Vermont Agency of Transportation  
**RECEIVED**

CK'D BY CLB OK'D BY CWC  
 April 13, 2018  
 RESUBMIT NO Approved AsNoted  
 BY C. CARLSON DATE 04/27/18

<b>HIGHWAY SAFETY CORP</b> GLASTONBURY, CT 860-633-9445		<b>CERTIFIED FABRICATOR</b>
ITEM 525.335 BRIDGE RAIL, GALVANIZED, 3 RAIL BOX BEAM ITEM 621.725 GUARDRAIL APPROACH, GALVANIZED, 3 RAIL BOX BEAM VT RT 15A BRIDGE No. 1 TOWN OF MORRISTOWN - LAMOILLE COUNTY, VT BRS 0240(3) S		
GENERAL CONTRACTOR SUB CONTRACTOR LAFAYETTE		HSC JOB NO. <b>2236</b> SHEET NO. <b>4 of 8</b>
DRAWN PAR CHECKED DATE 04-09-18 SCALE NONE SIZE D

PARTIAL PLAN VIEW  
 SOUTHWEST CORNER

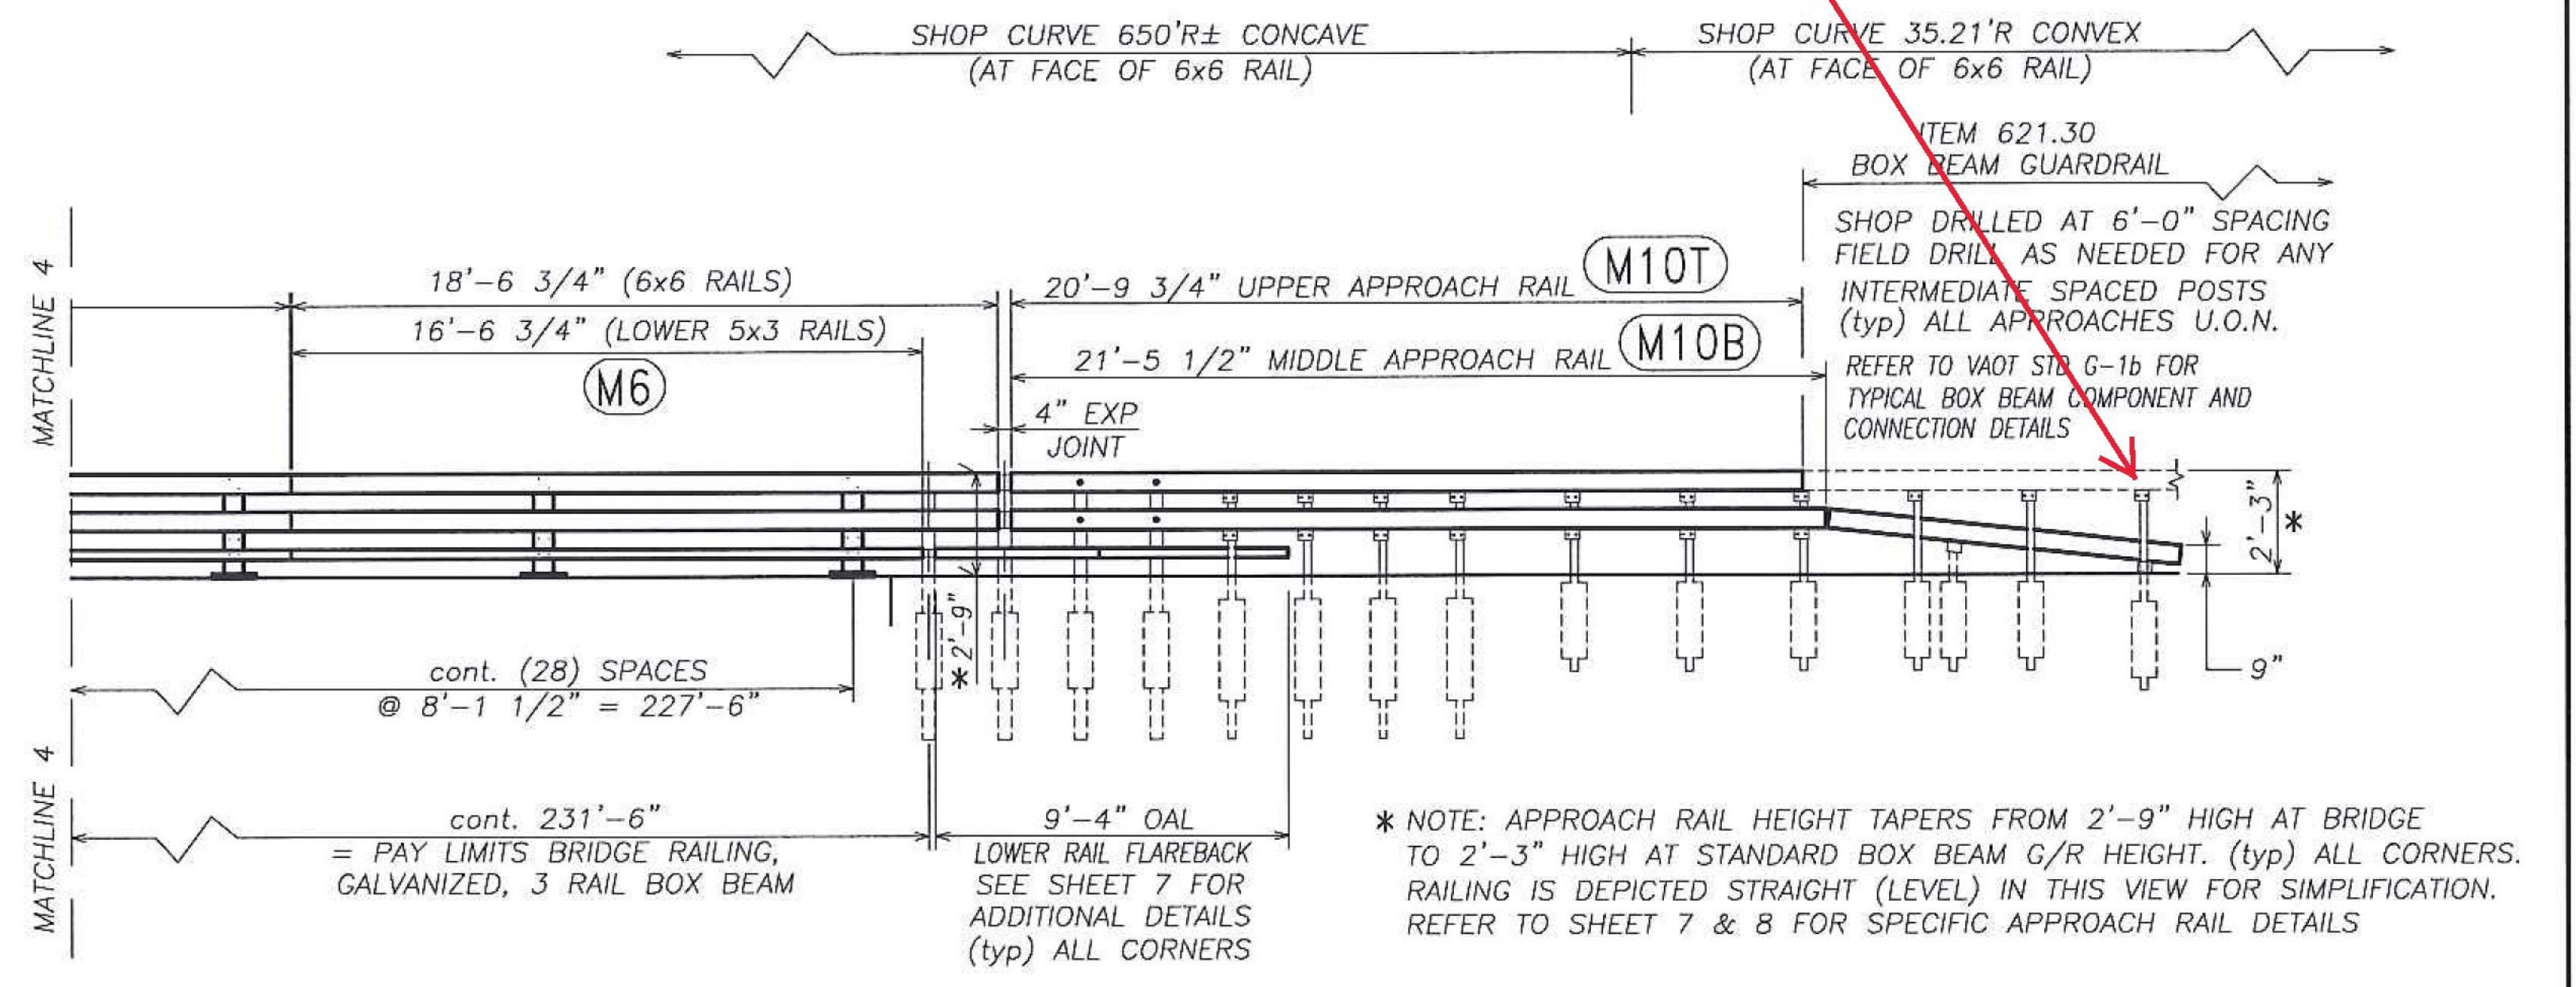
Won't affect fabrication but per standard S-364B, approach rail pay limits should extend to this post
